UNITED STATES PATENT AND TRADEMARK OFFICE

10/726,490

Office Action Summary	Application No.	Applicant(s)	
	10/726,490	CHEN ET AL.	
	Examiner	Art Unit	
	Scott Bauer	2836

DETAILED ACTION

FIG. 4

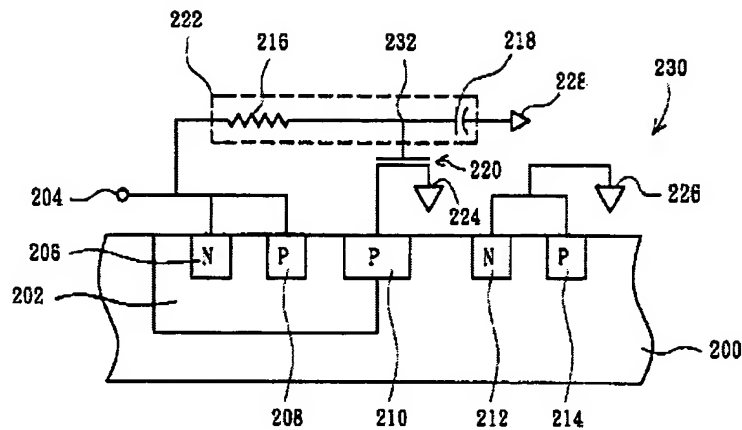
7. With regard to Claim 1, Su et al., in Figure 4, teaches an electrostatic discharge protection structure comprising an SCR (230) a MOS transistor (220) and an RC control circuit (222) coupled to the gate of the MOS transistor (column 4 lines 16-18). The

control circuit is in response to a first voltage applied to the first and second gates providing a first holding voltage to the SCR to keep the SCR from latching-up, and in response to a second voltage applied to the first and second gates providing a second holding voltage to the SCR to keep the SCR in the latch-up state (column 4 lines 42-58).

Su et al. does not teach that a first transistor of a first type is integrally formed with the SCR including a first gate. Su et al. further does not teach that the MOS transistor (220) is integrally formed with the SCR including a second gate.

It would have been obvious to one of ordinary skill in the art at the time the invention was made to combine the teachings of Su et al. with Zunino by replacing the SCR (200) and the MOS transistor (220) taught by Su et al. with the PNP transistor (Zunino Figure 1) taught by Zunino. In the ESD protection device taught by Su et al. in

20. With regard to Claim 14, Su et al. in view of Zunino teaches the circuit of Claim 8. Su et al. in figure 4, further discloses that the SCR is coupled between a contact pad (204) and a voltage line (226).

FIG. 1

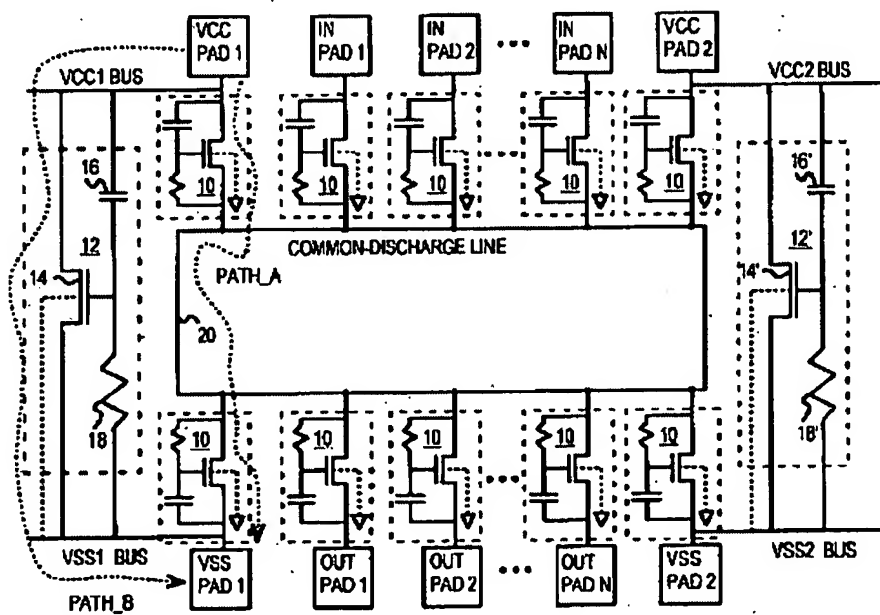
Tong et al., in figure 1, discloses an ESD protection circuit comprising a plurality of pads, first and second voltage sources of first and second voltage levels, and a plurality of ESD protection circuits (10 & 14). Tong et al. further teaches that each ESD protection device contains a control circuit comprising a capacitor (16) and a resistor (18).

29. With regard to Claim 17 & 29, Su et al. in view of Zunino and further in view of Tong et al. discloses the circuit of Claim 16 and the method of Claim 28. Tong et al. further discloses that an ESD device (14) is coupled between the first and second voltage lines (VCC & VSS) and that the remaining ESDs are each coupled between a corresponding contact pad and the second voltage line.

30. With regard to Claim 18 & 30, Su et al. in view of Zunino and further in view of Tong et al. discloses the circuit of Claim 17 and the method of Claim 29. Tong et al. further discloses, in Figure 1, that the ESD pulse is discharged from one of the contact pads (VCC PAD 1) via a voltage line (VCC1) to voltage line (VSS 1). This event is depicted by PATH_B in Figure 1.

31. With regard to Claims 19 & 31 Su et al. in view of Zunino and further in view of Tong et al. discloses the circuit of Claim 17 and the method of Claim 29. Tong et al., in Figure 1, further discloses that an ESD pulse is discharged from the first voltage (VCC 1) line via the second voltage (20) line to one of the contact pads (VSS PAD 1) via PATH_A.

32. With regard to Claim 20 & 32, Su et al. in view of Zunino and further in view of Tong et al. discloses the circuit of Claim 17 and the method of Claim 29. Tong et al., in Figure 1, further discloses that an ESD pulse is discharged from one of the contact pads

(VCC PAD 1) via the second voltage line (20) to a different contact pad (VSS PAD 1) via PATH_A.
